# **SERVICE BULLETIN**

#### M1456

# M1456: 2017 - 2018 SOFTAIL - OIL SPINNER RETENTION

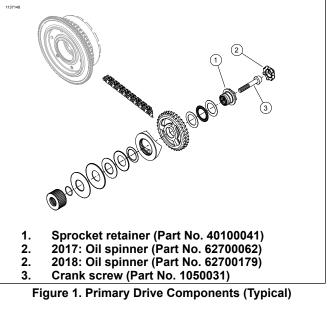
Refer to Figure 1. This bulletin informs dealers of a production change which addresses oil spinners (2) that could detach from the sprocket retainer (1) on some Softail models with wide primary chaincases. Refer to Table 1.

- 2. Refer to Figure 1. Determine that the oil spinner (2) has lost retention.
- 3. Upon assembly, replace crank screw (3) and both sprocket retainer and appropriate spinner for the model year.
- 4. Thoroughly clean any residual plastic from the primary chaincase.
- 5. Assemble with **new** primary cover gasket. See the service manual.

- 1. Remove primary cover. See the service manual.
  - a. Determine the source of the sound.
  - b. If the spinner has lost retention, inspect the compensator assembly for wear and service as needed.
